Addendum No. 1
HAWA Project No. 23100

AGR-240001 CPL Chiller Replacement

Date	April 09, 2024
Project Title	Ohio Facilities Construction Commission CPL Chiller Replacement
To	All Plan Holders
Purpose	Modify the Bid Documents
Distribution	All Plan Holders Ohio Department of Agriculture Ohio Facilities Construction Commission

BASEMENT FLOOR HVAC PLAN
SCALE: 1/8" = 1'-0"

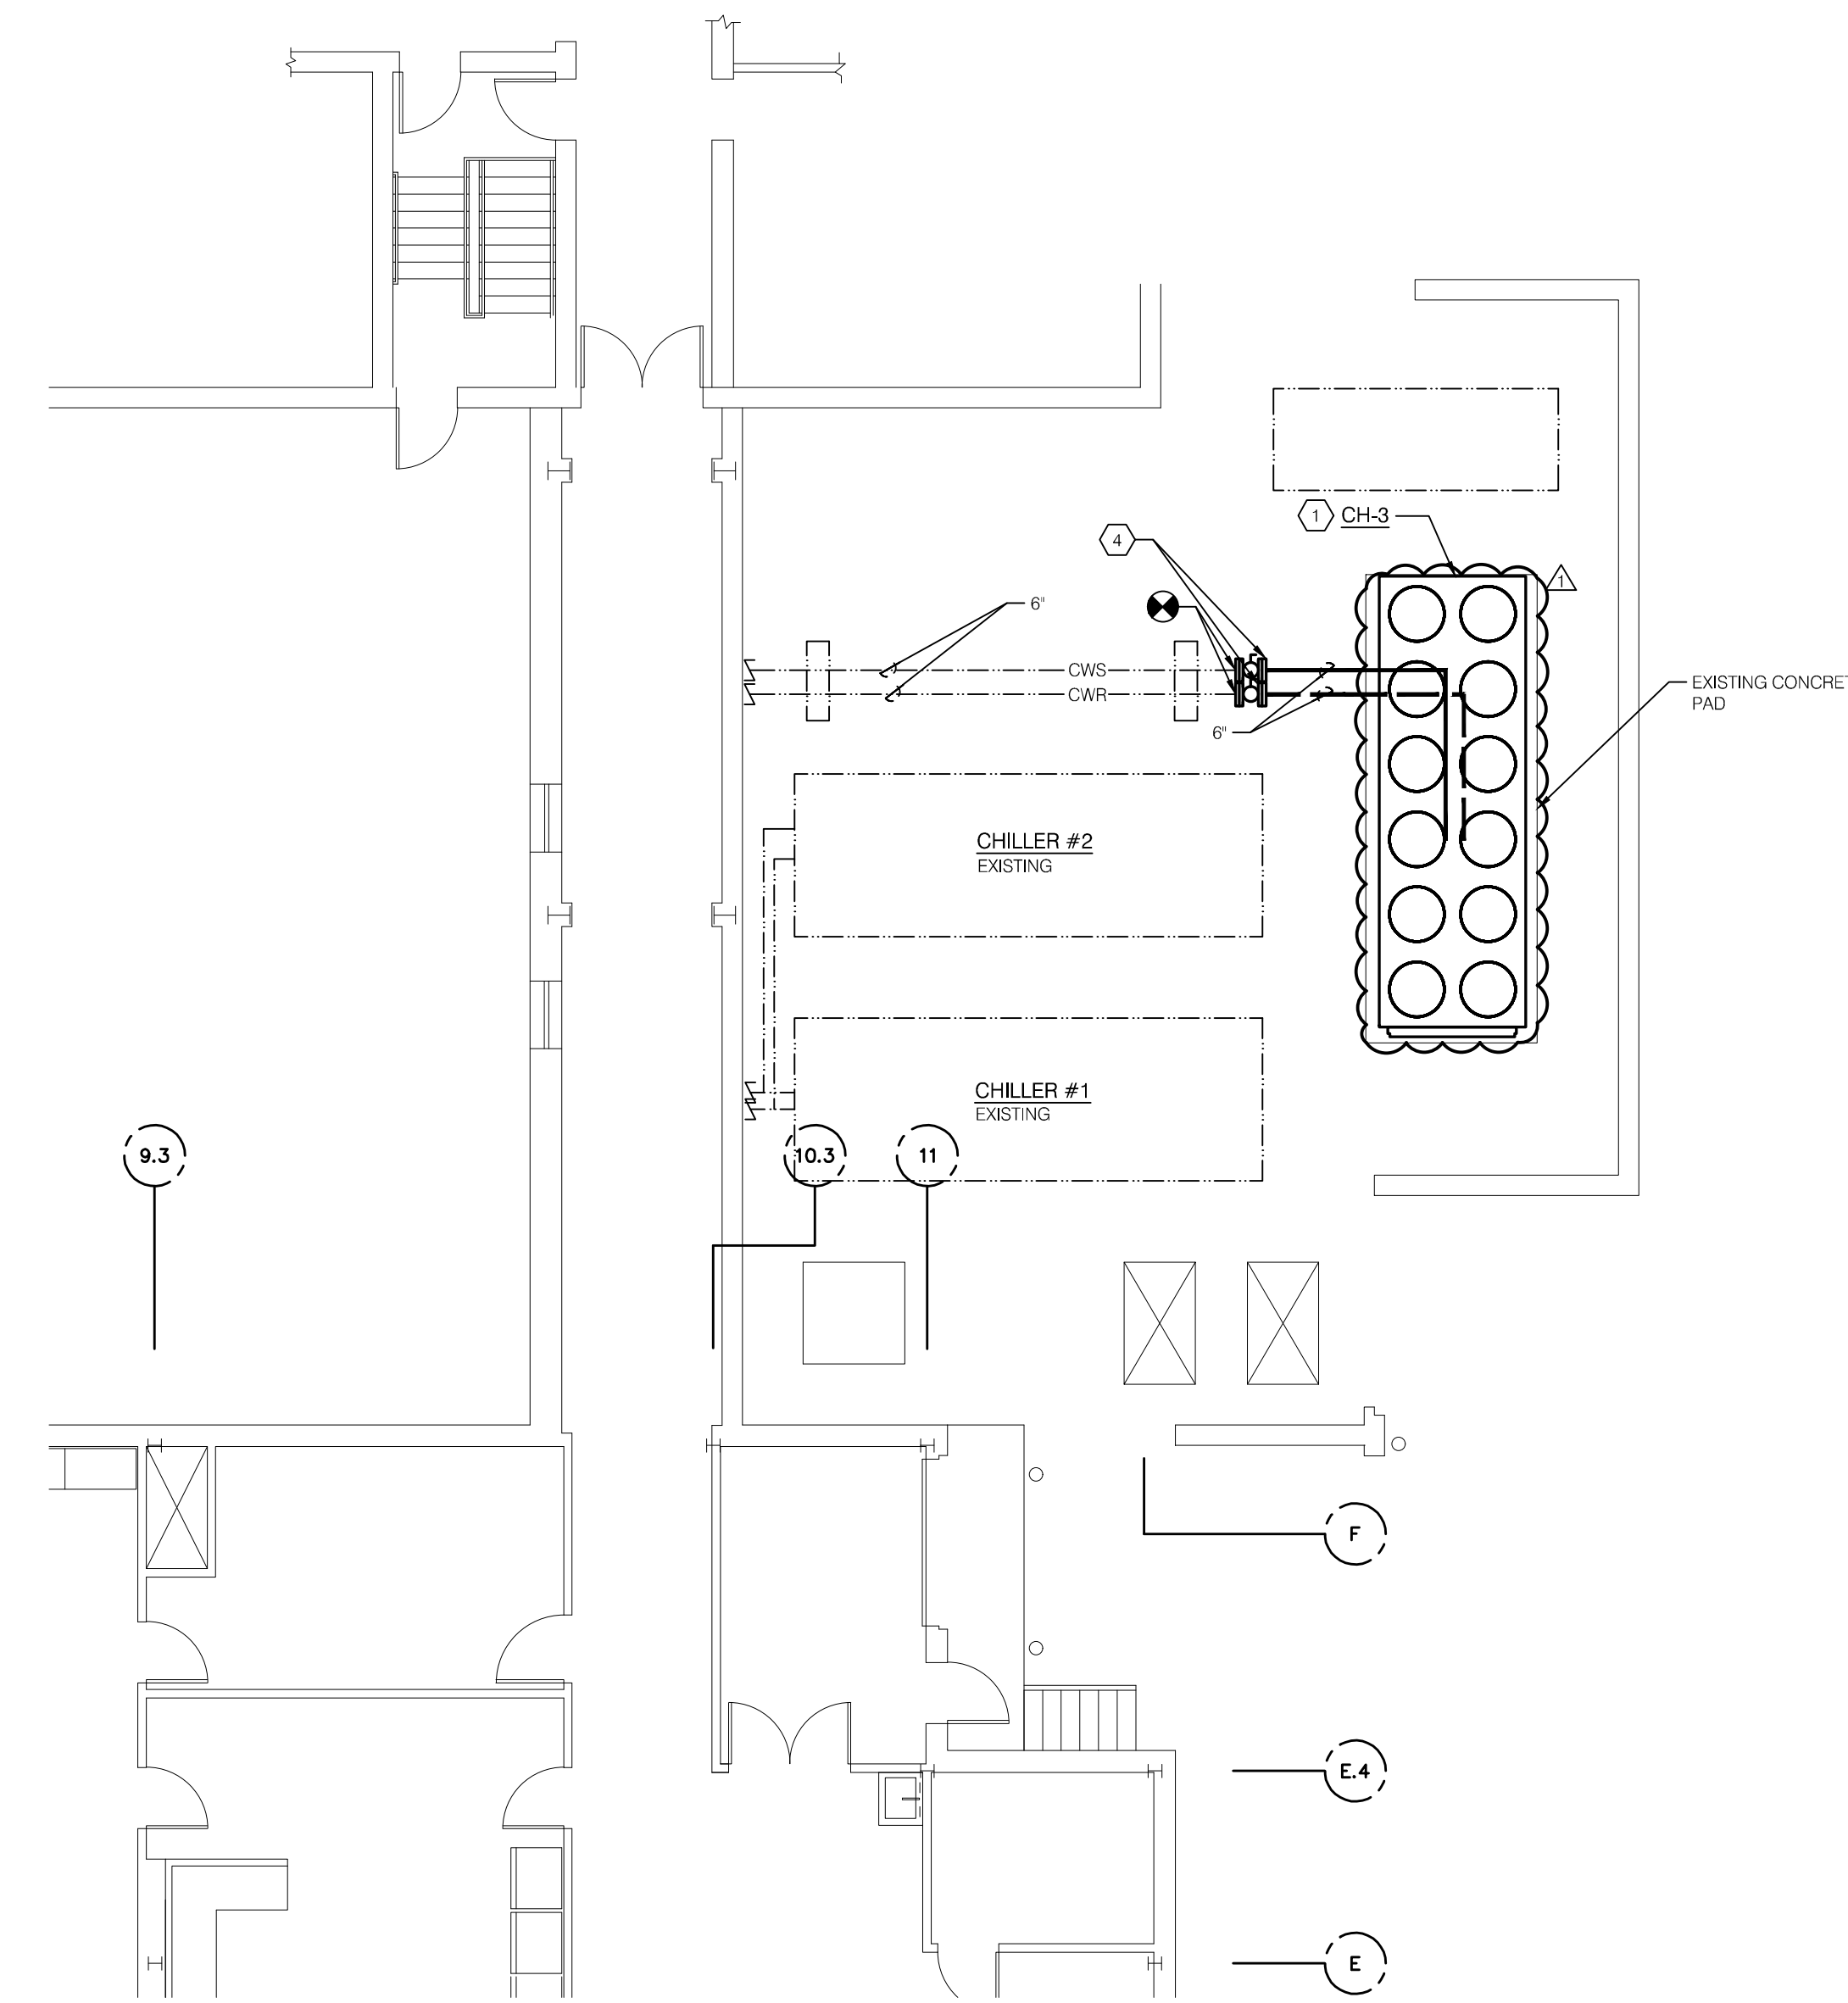
- Sheet M200: BASEMENT FLOOR HVAC PLAN
 - o Rotated new chiller.
- Sheet M500: HVAC DETAILS
 - o Revised piping valves in the new piping schematic.

BASEMENT FLOOR ELECTRICAL PLAN
SCALE: 1/8" = 1'-0"

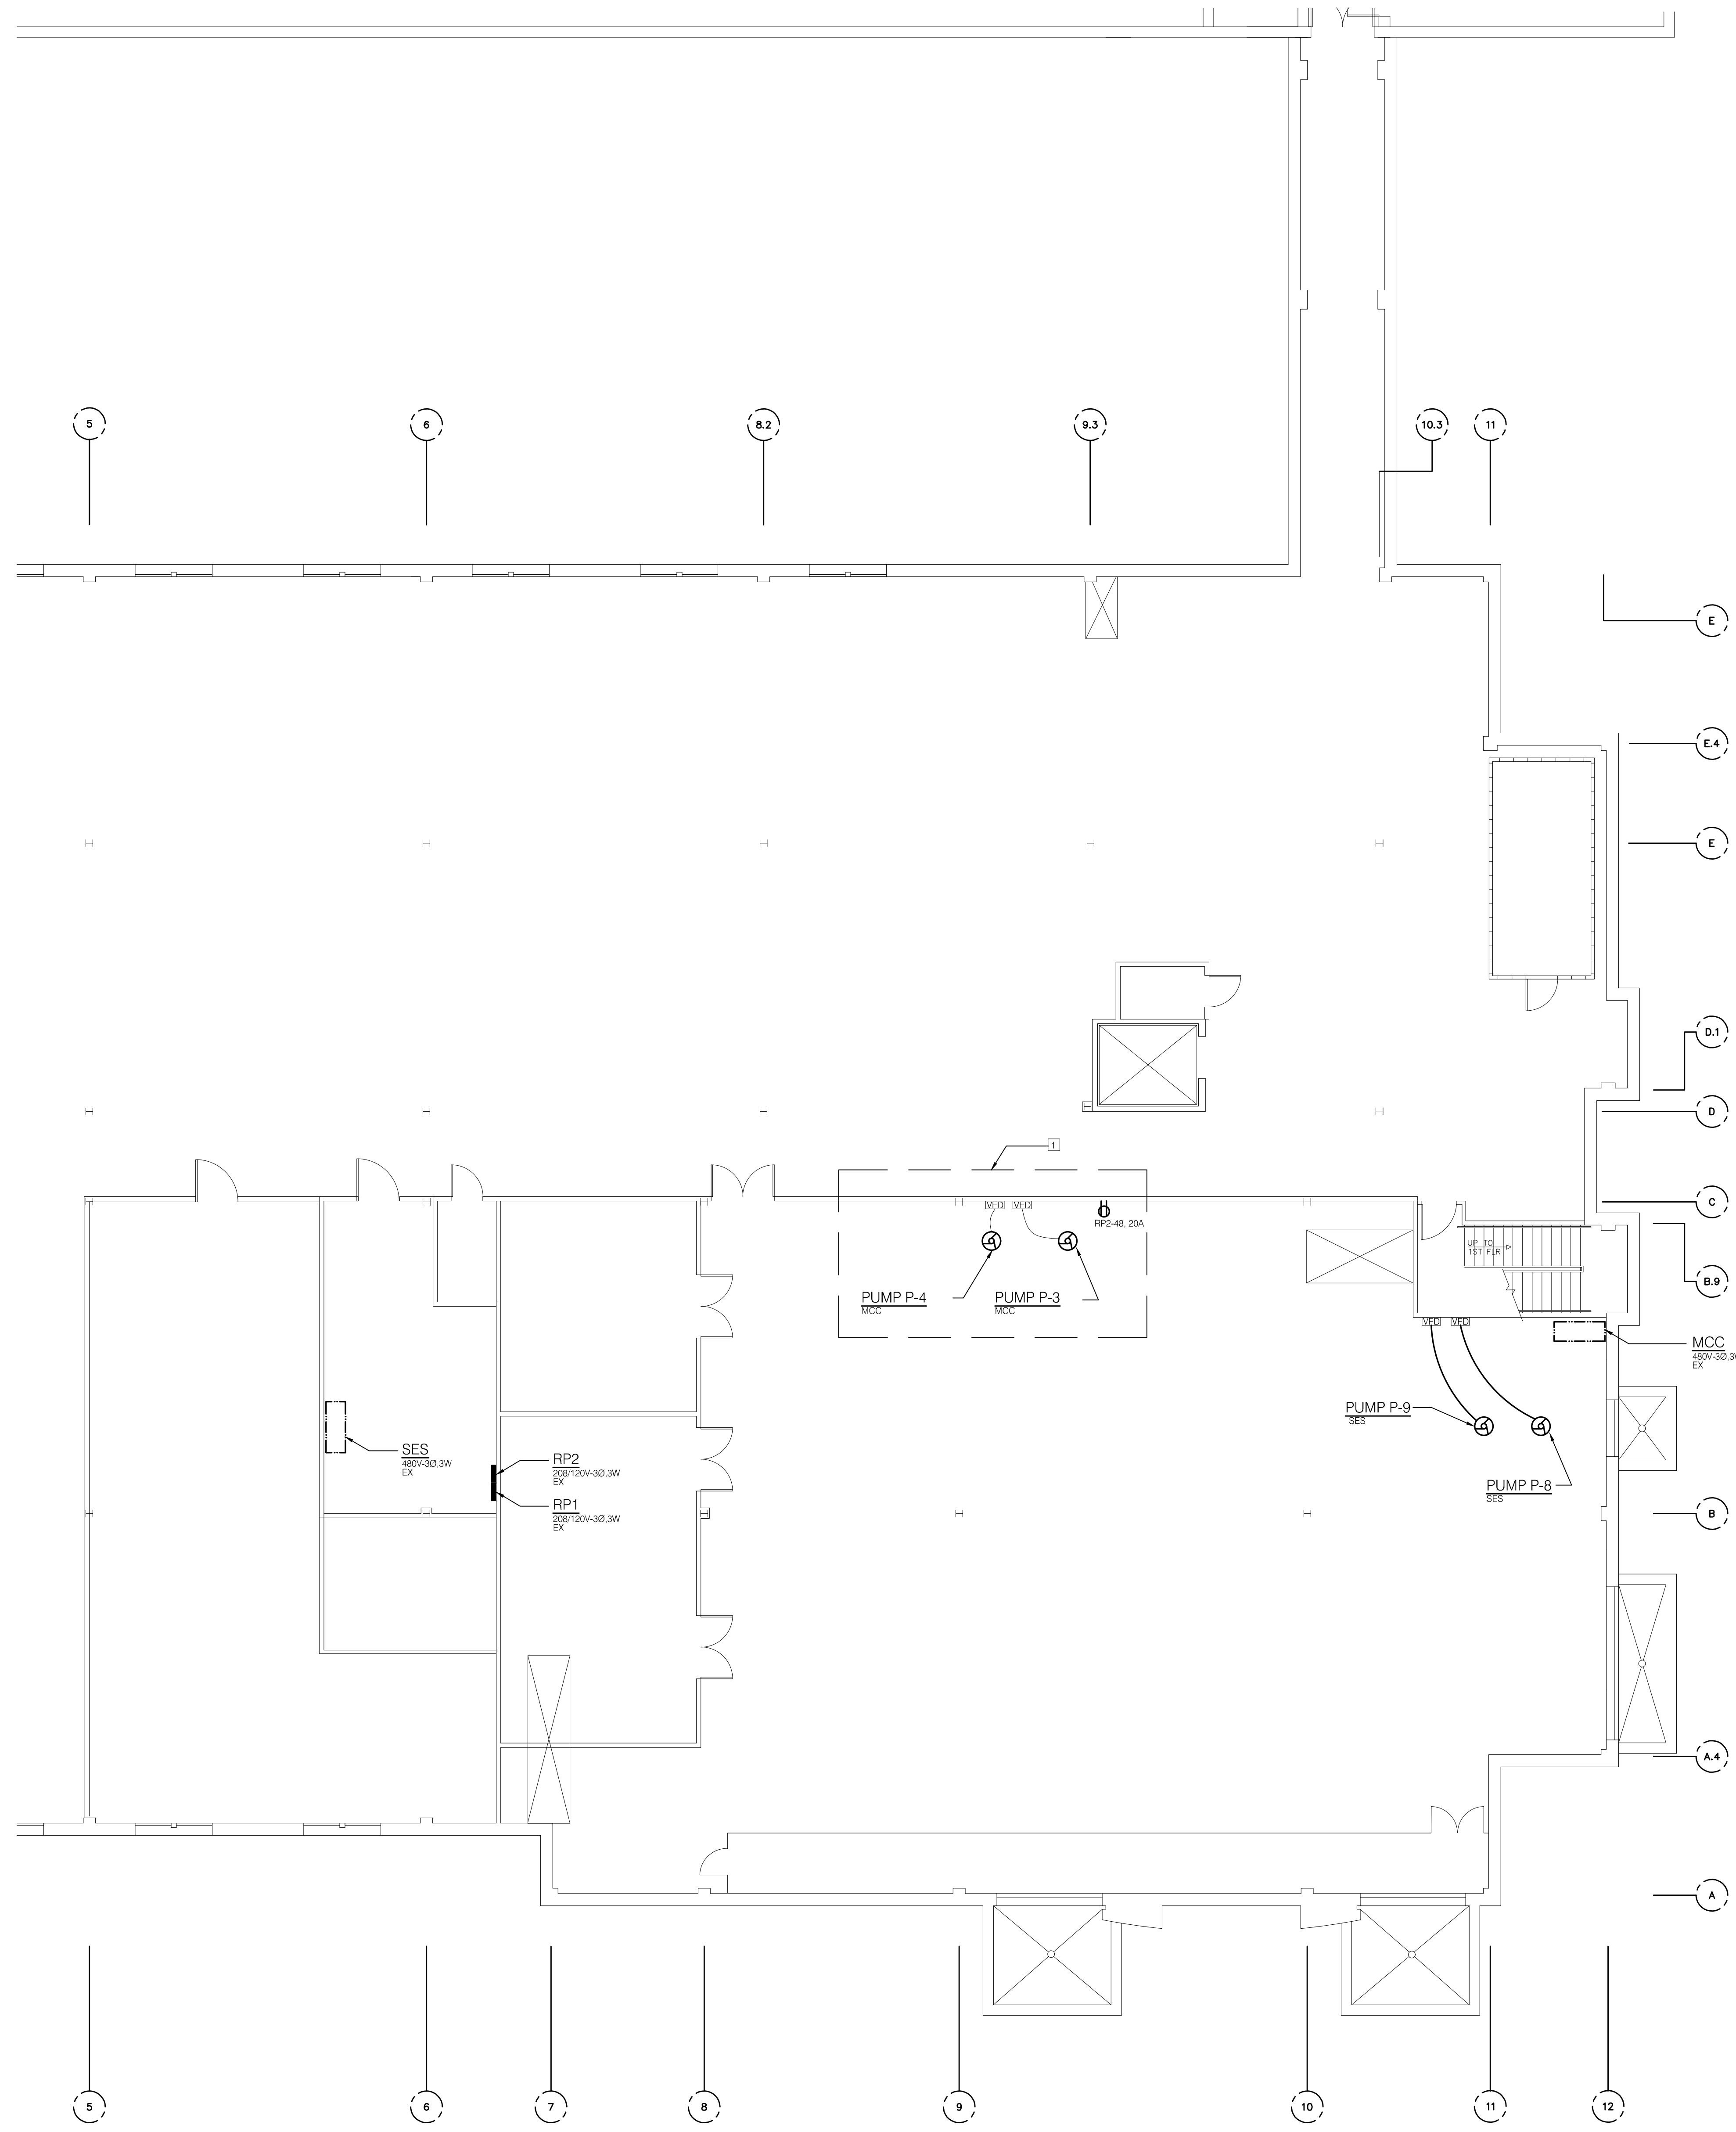
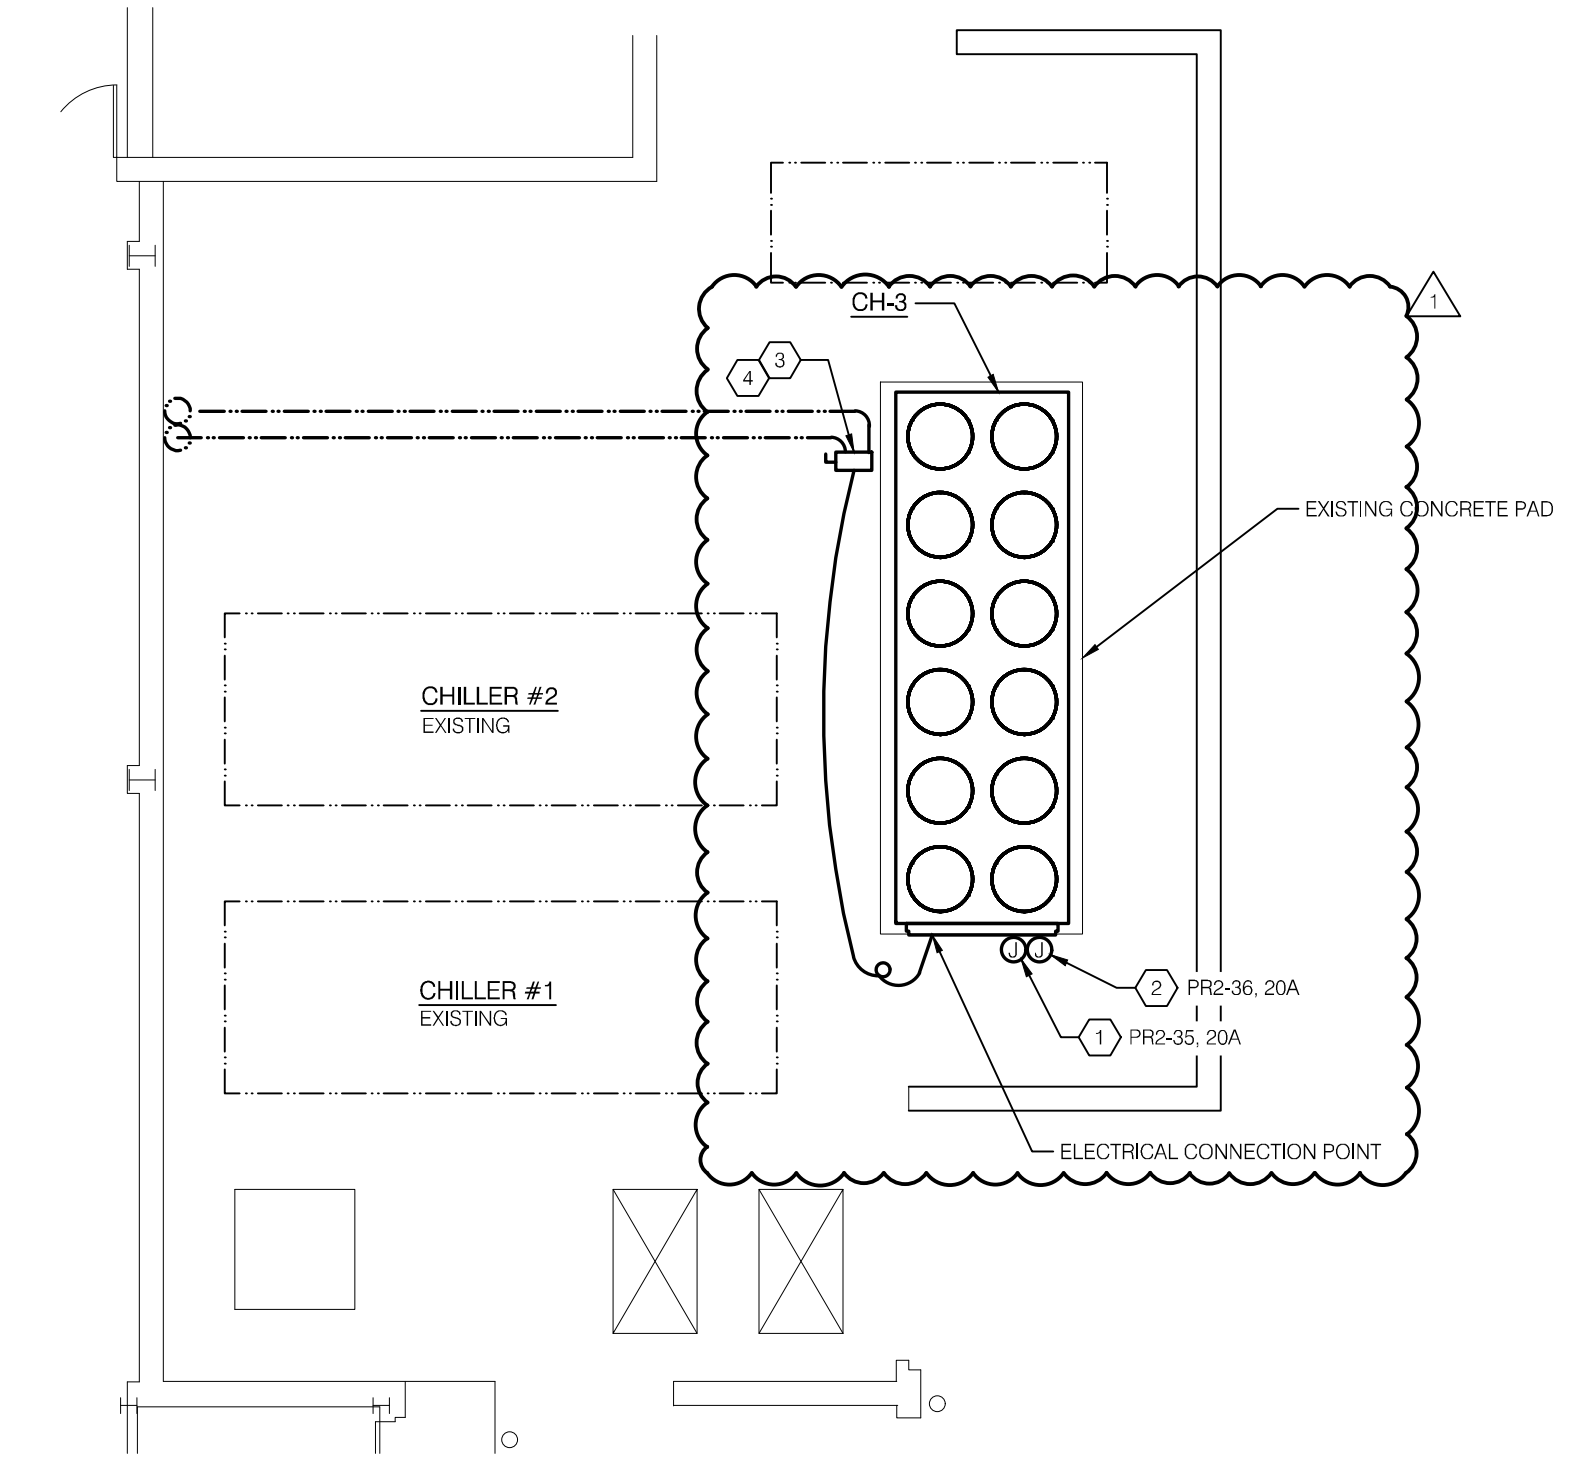
- Sheet E200: BASEMENT FLOOR ELECTRICAL PLAN
 - o Relocated electrical feed to chiller's electrical connection point.
